## **Summary of Submission**

### **Parramatta Light Rail Stage 2**

Property: 91 South Street, Rydalmere NSW 2116.  
Lot 322 / DP15160.

91 South Street, Rydalmere - Carport vehicle access

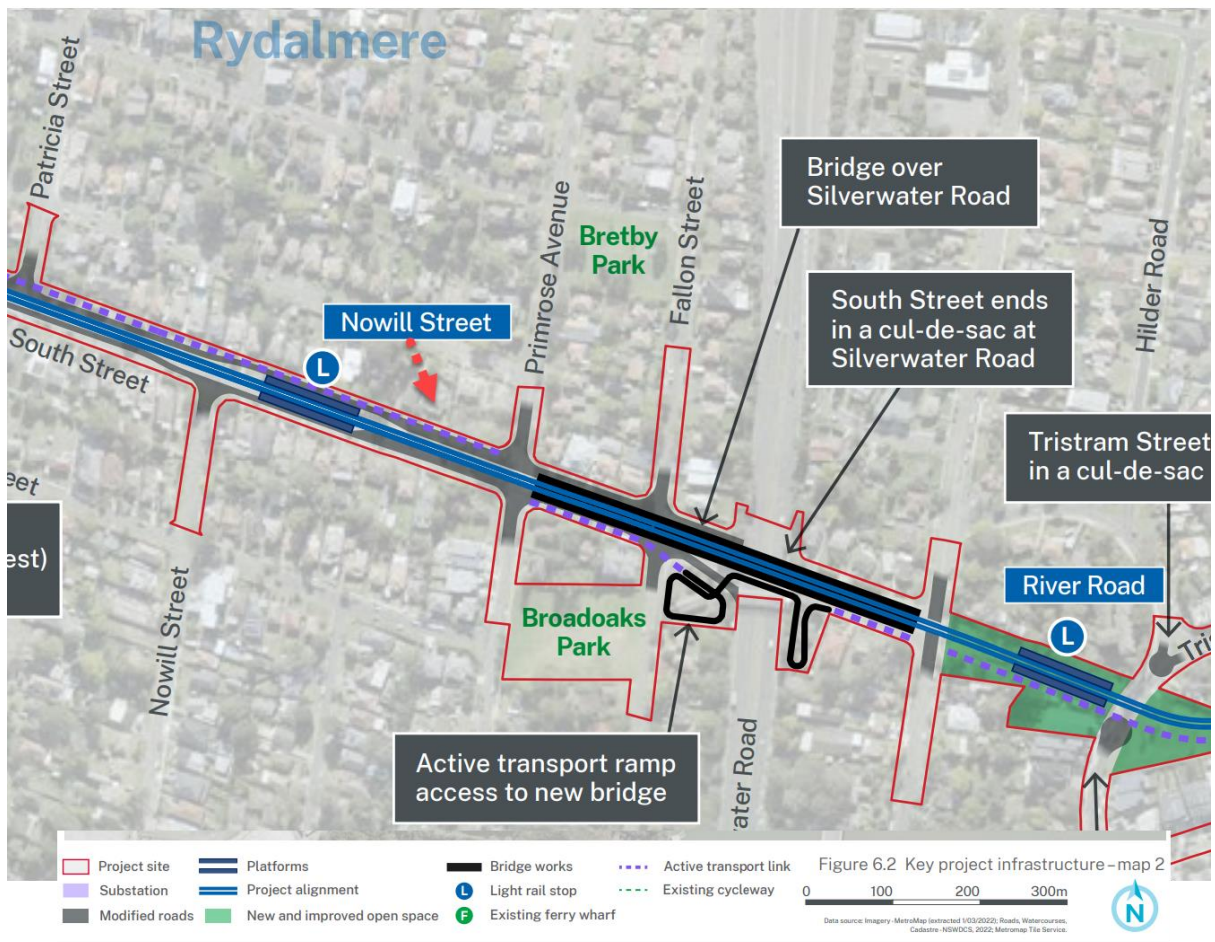
Current access is driveway from South Street to attached semi enclosed Carport attached to their residence, providing direct short access to the main living room of the residence. Carer (mum) drives into the car port which has auto controlled garage door to front. The carport has been widened to allow space for Mum to assist Dad to exit the car and then move short distance to door access direct to the living room. See pictures in attachment. Dad requires a "wheelie walker" or two walking sticks to move short distances. Longer distances he requires a wheelchair. Dad is a "My Aged Care" customer with a "Home Care Package with Dementia supplement". This provides Government support to enable his continued living in his home with the support of Mum who is his full time carer.

The EIS is not specific in relation to the impacts on Mum and Dad's property, but includes comments that "some properties will be able to use alternative street access". Their property does have a rear access to Dorothy Street, but the distance of movement required from Dorothy Street to the house is too far for dad to navigate.

Hence, we request to be consulted ASAP and provided details of what provision will be made for them to continue to use the South Street driveway access to the property in the operational phase of the project. Without this access it is unlikely that dad could continue to reside at the property which would cause highly significant mental and emotional cost to my parents (and likely also significant monetary costs).

91 South Street, Rydalmere - Driveway vehicle access

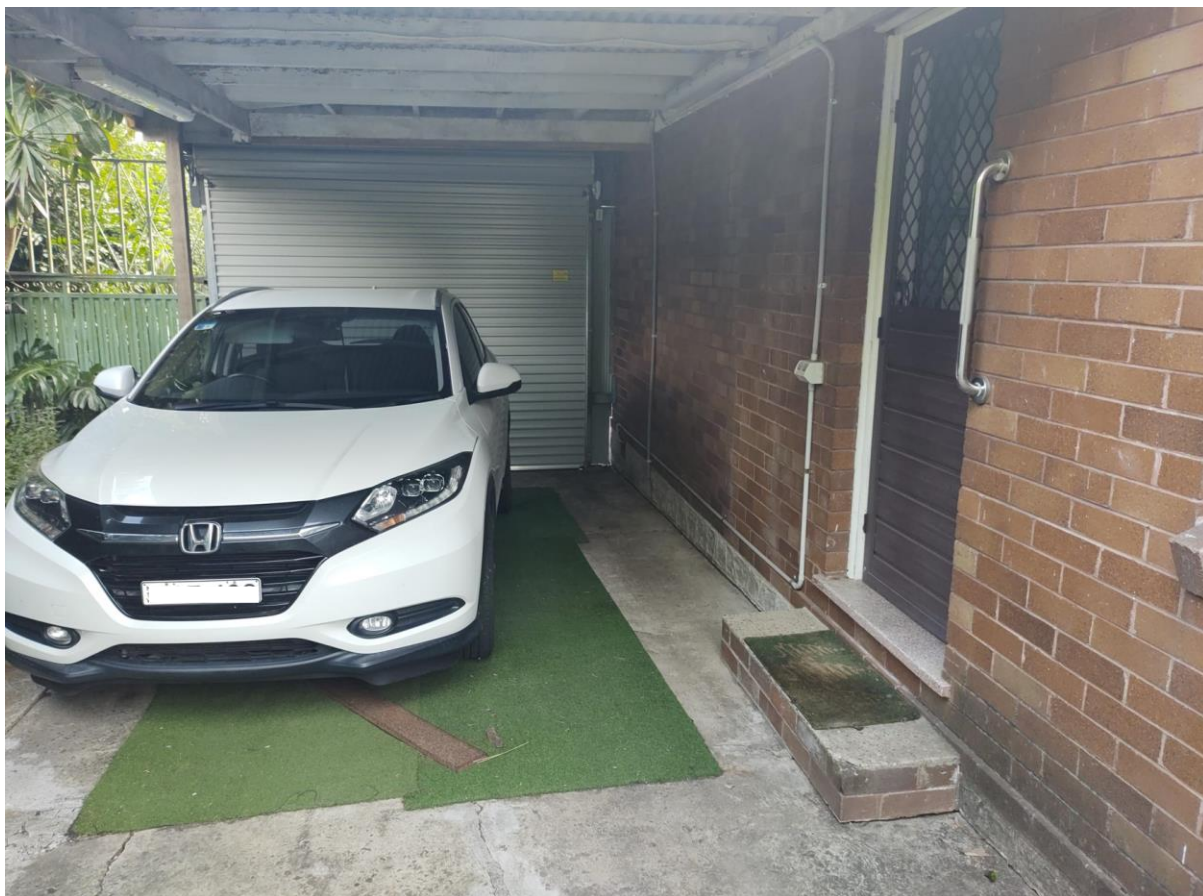
Another significant impact will be the relocation of vehicle traffic which is currently 22 metres from the main bedroom to be within 9 metres of the main bedroom. The EIS section 10.19 states no residences will be affected to an extent that any noise mitigation measures are warranted.

This significant closer vehicle noise has potential for interrupted sleep and adverse health affects on both Mum and Dad. It is requested that provision to reduce the noise to the current levels be implemented.
